**A. REPORT TO THE HEARING EXAMINER**

**Project Name:** Renton Commons

**File Number:** LUA16-000425, CU-H, SA-H, ECF, MOD, MOD, MOD

**Project Manager:** Rocale Timmons, Senior Planner

GRADING  
 AND PAVING  
 PLAN

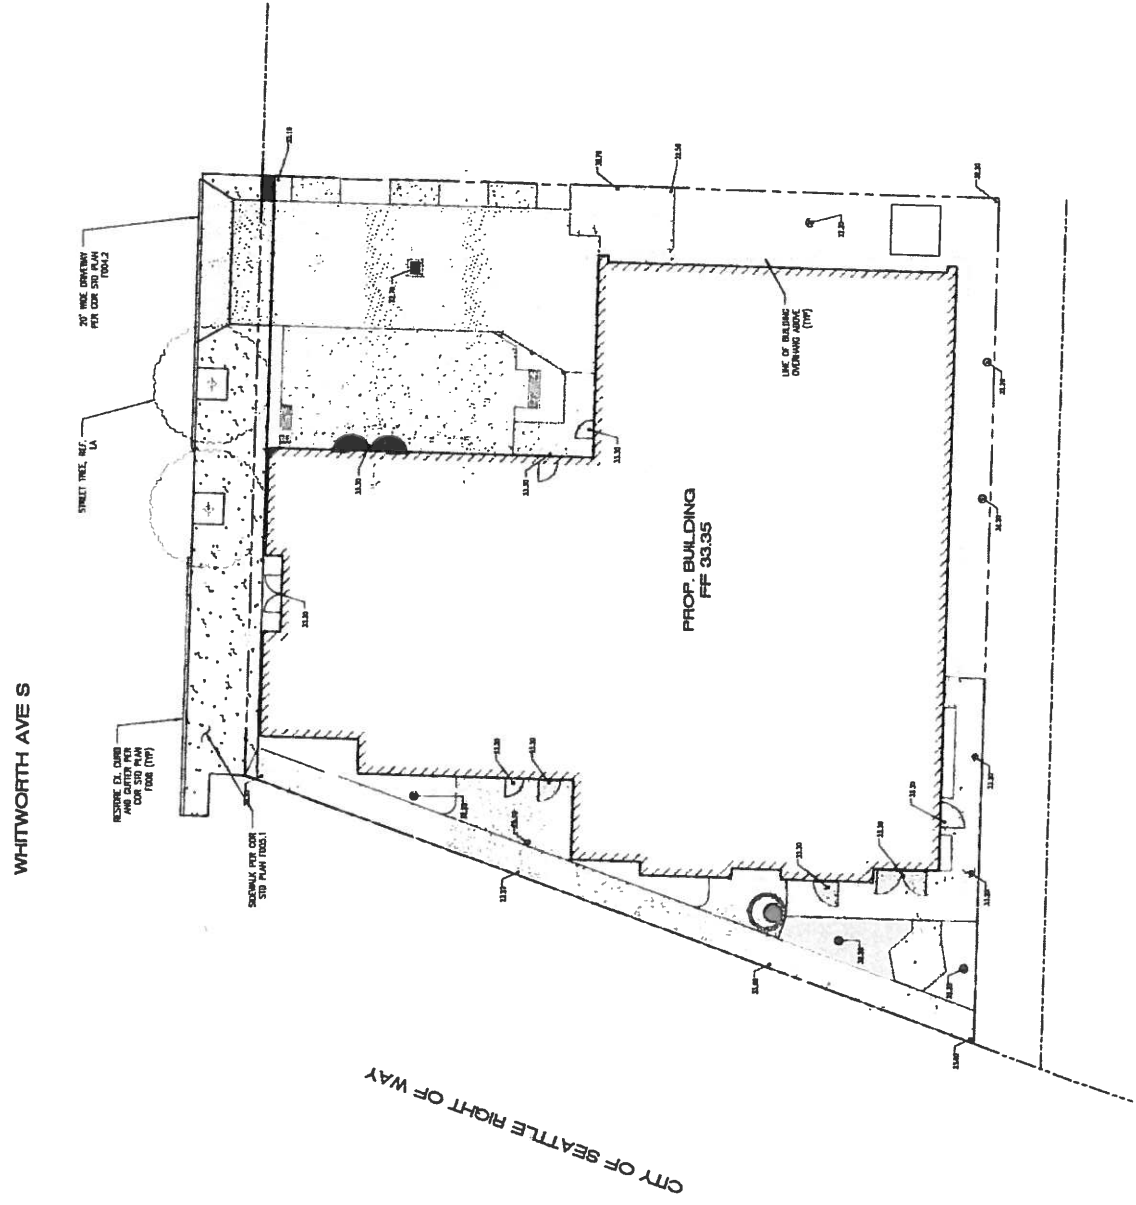
*Finally, the proposed plan does not include a suitable transition to the adjacent sidewalk north and south of the site. The transition of new sidewalk may need to be extended slightly beyond property frontage to the north and south sides and it would likely need to be field verified where the transition should occur. Therefore staff recommends a condition of approval requiring the applicant to submit a revised paving plan which includes a suitable transition to the existing sidewalk, north and south of the subject property. The revised paving plan shall be submitted to, and approved by, the Plan Reviewer prior to construction permit approval.*

8. The applicant shall submit a revised paving plan which includes a suitable transition to the existing sidewalk, north and south of the subject property. The revised paving plan shall be submitted to, and approved by, the Plan Reviewer prior to construction permit approval.
